**RE: Administrative Design Review Case No. PADR-002143-2023
706 East Colorado Street**

DESIGN REVIEW STAFF REPORT – COMMERCIAL / INDUSTRIAL / MIXED USE

706 East Colorado Street
Address

PADR-002143-2023
Case Number

West & East Elevations
Scale: 3/16"=1'-0"

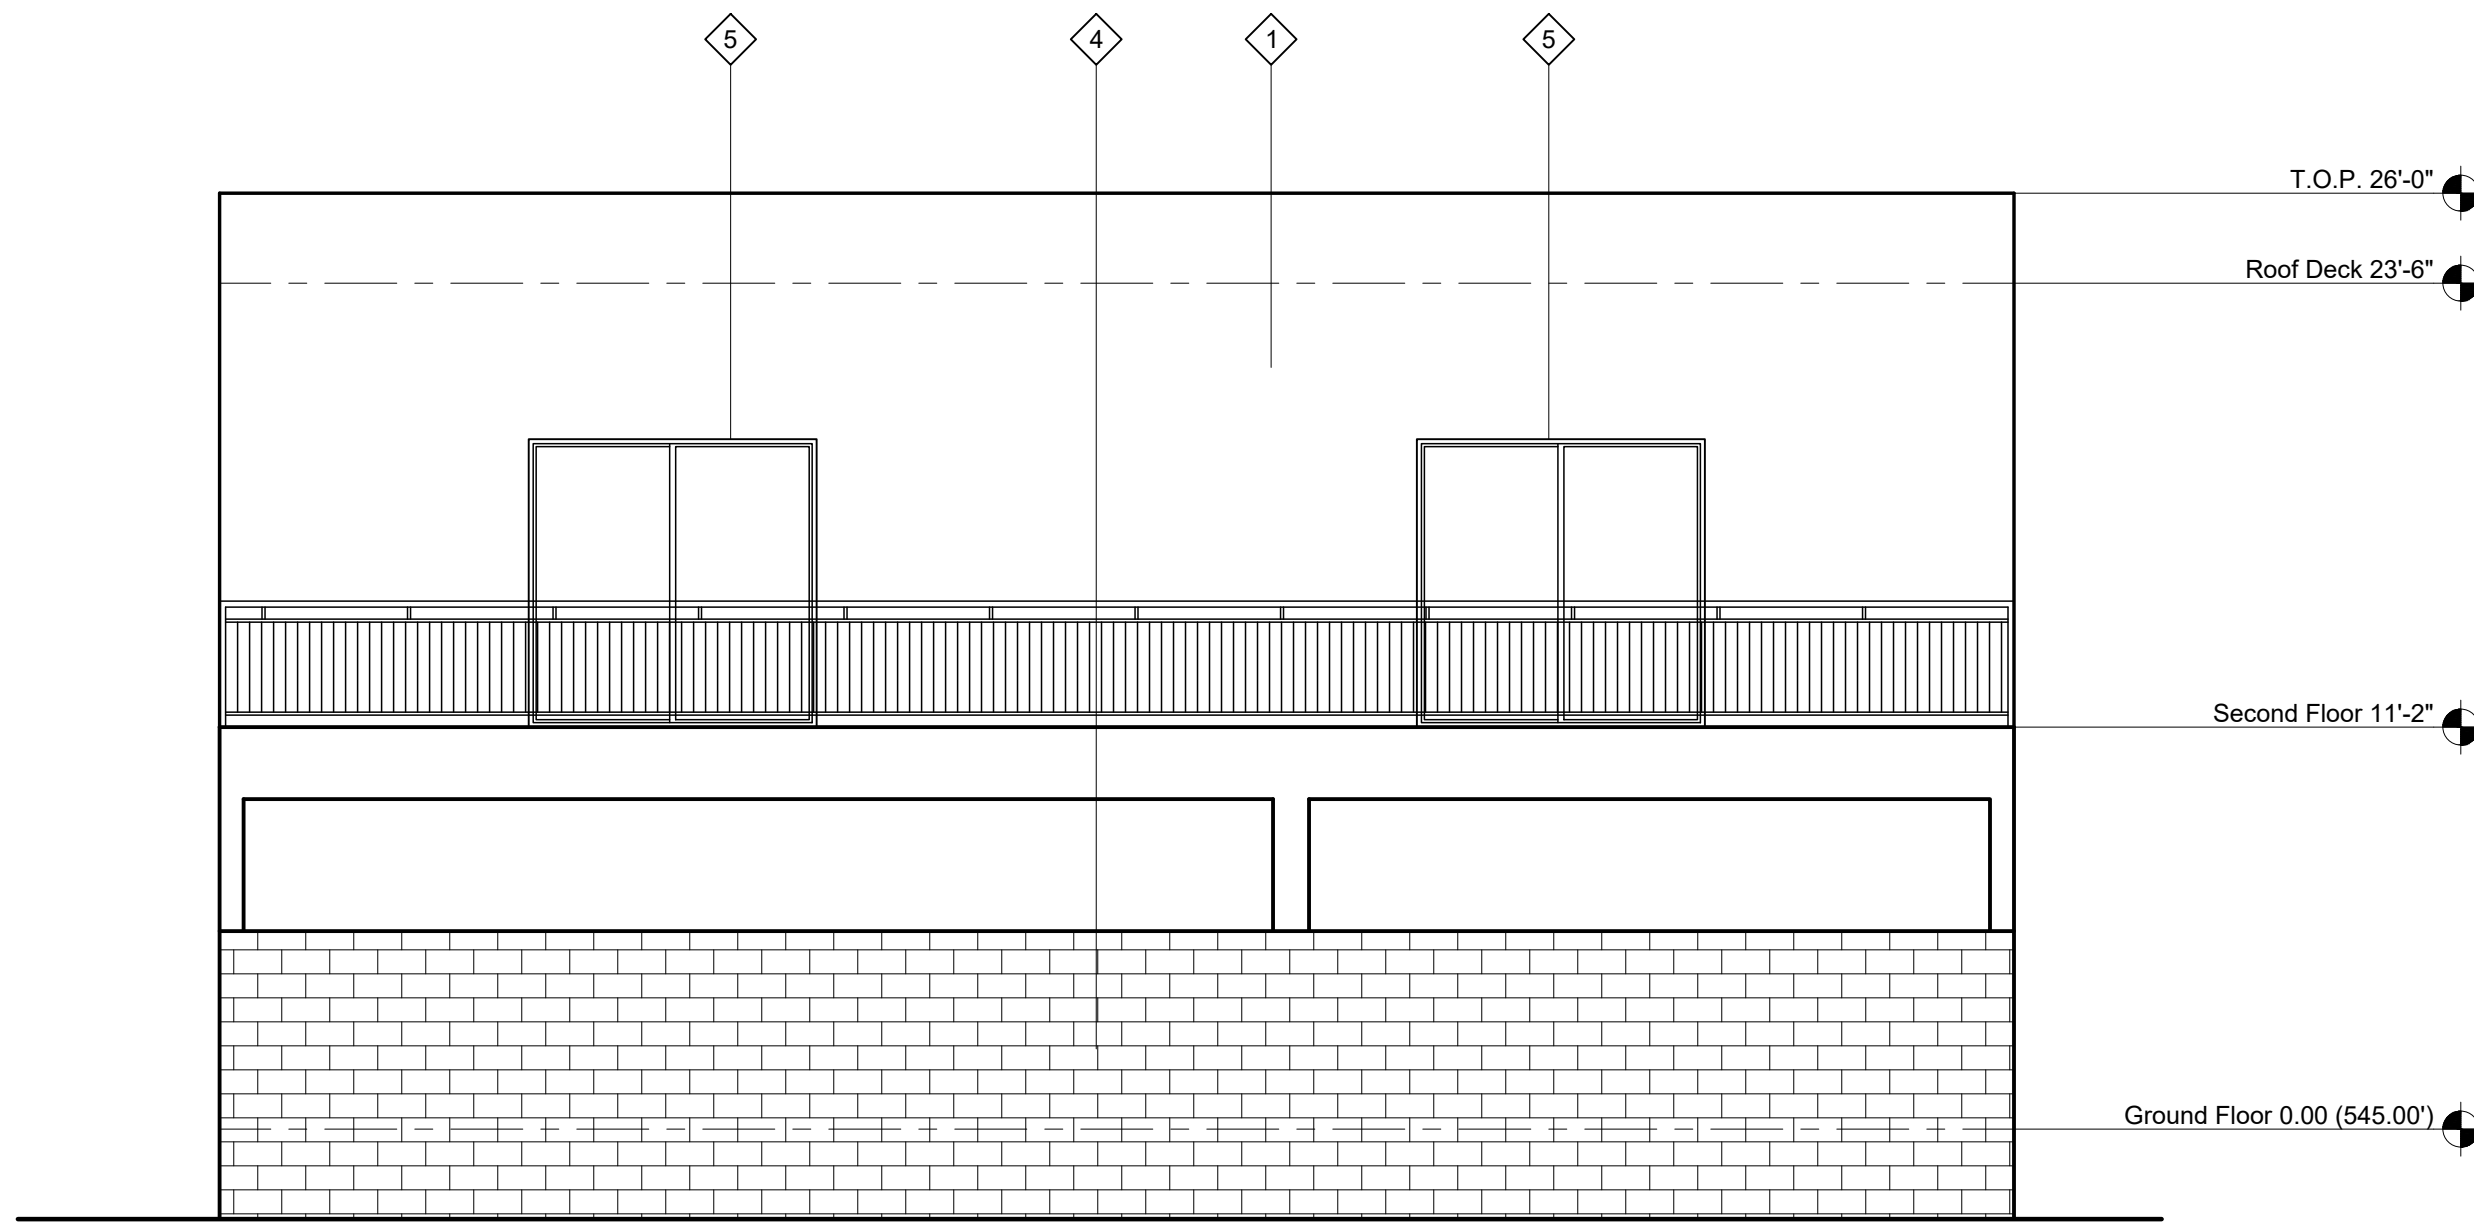
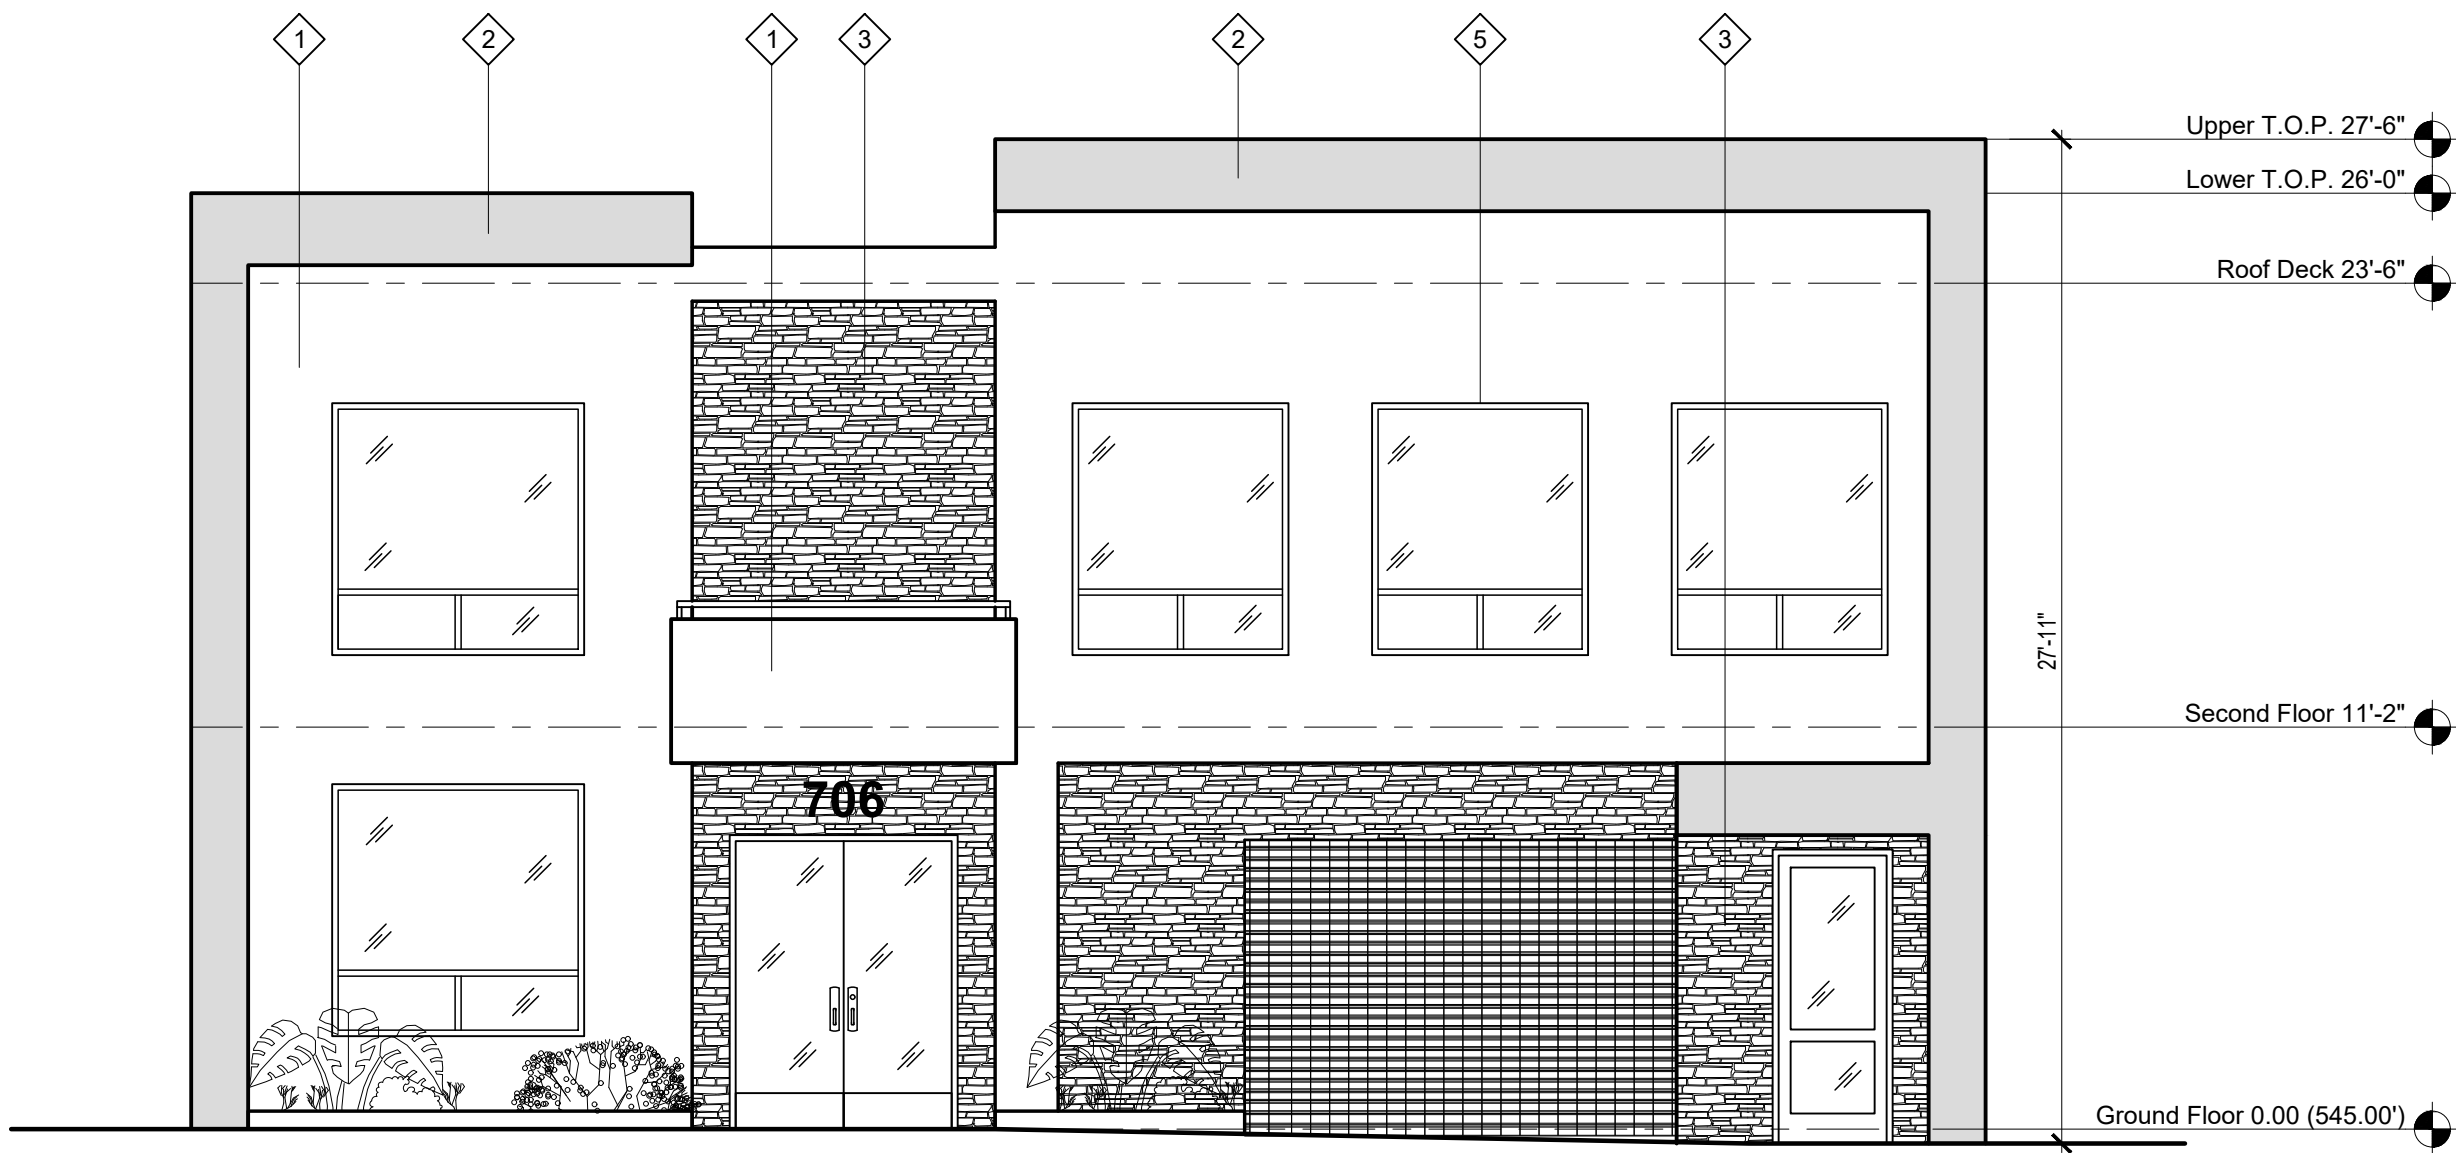
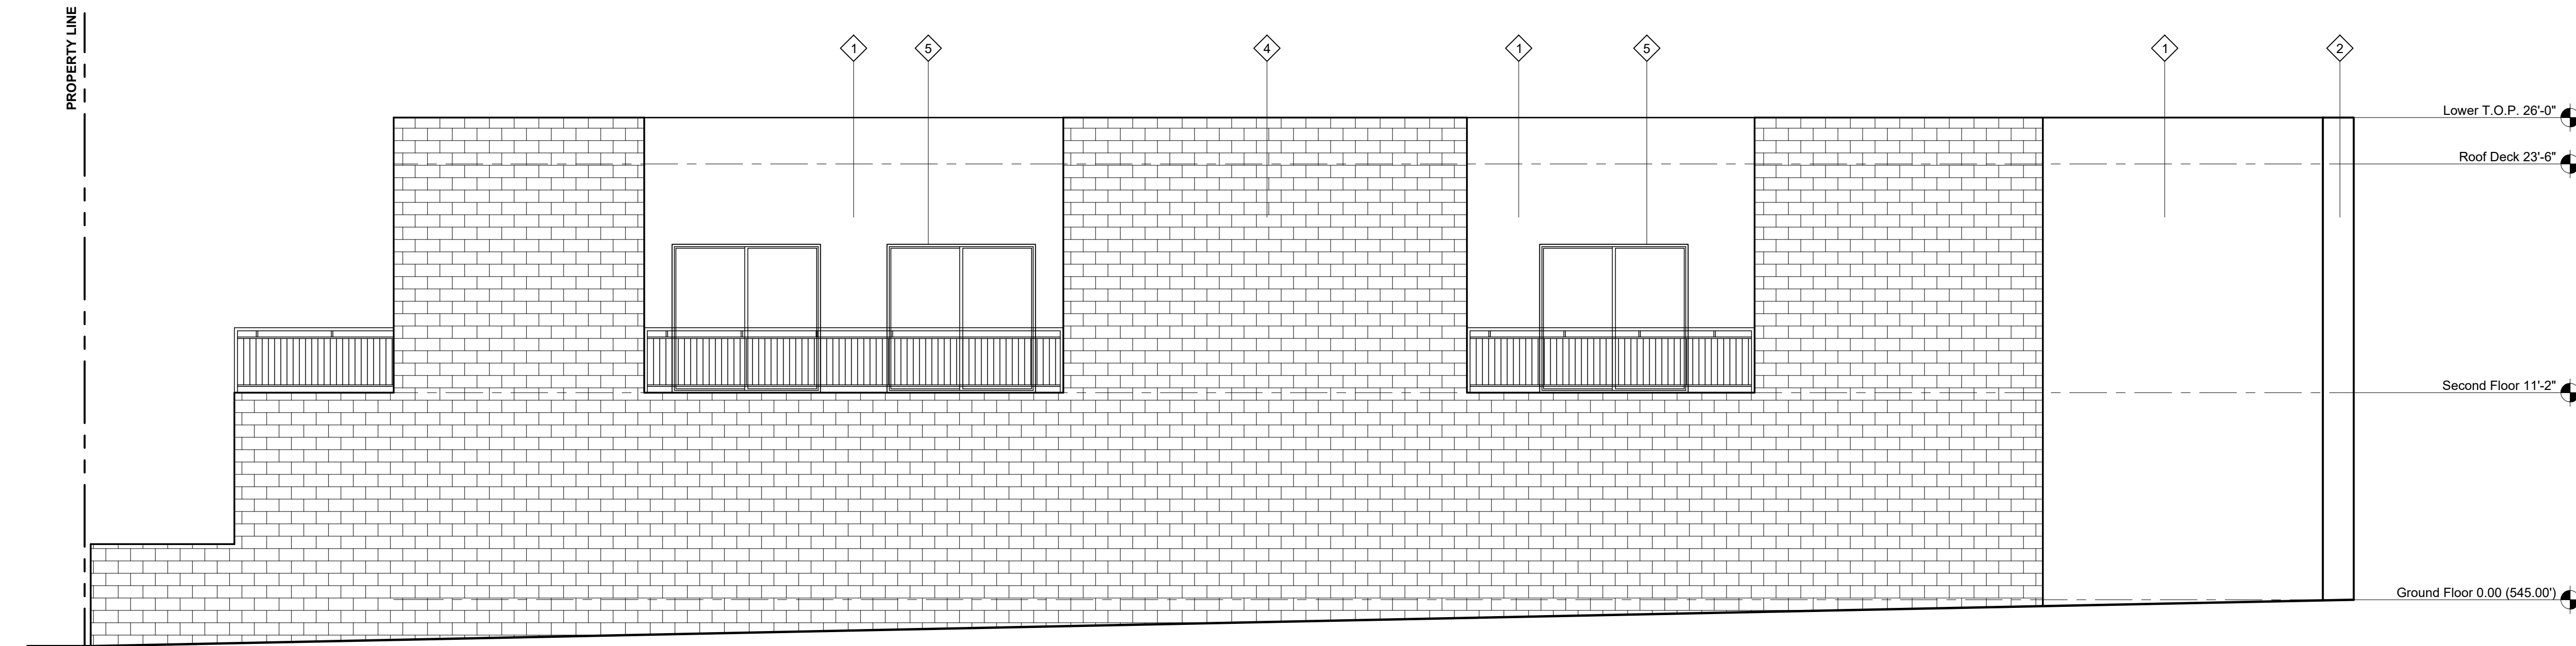
Lighting detail is not depicted on the plans, as required by Glendale Municipal Code, §30.30.040. A condition is included to provide a cut sheet corresponding to proposed lighting on the new building and show site lighting and fixtures on the new building, limiting their location to main entry, egress door, and vehicle entrance for staff review and approval.

- Additional comment(s) and/or attachment(s).
GWP will need to conduct a site visit to verify existing electrical overhead line clearances. Project to transfer these overhead line clearances to their elevation plans.

1. The specifications (cut sheets) for site lighting and the exterior light fixtures on the new building and locations shall be submitted to staff for review and approval prior to plan check submittal. The exterior lighting shall be appropriate to and consistent with the style of the new building. The exterior lighting shall be limited to their location to the main entry, egress door, and vehicle entrance.
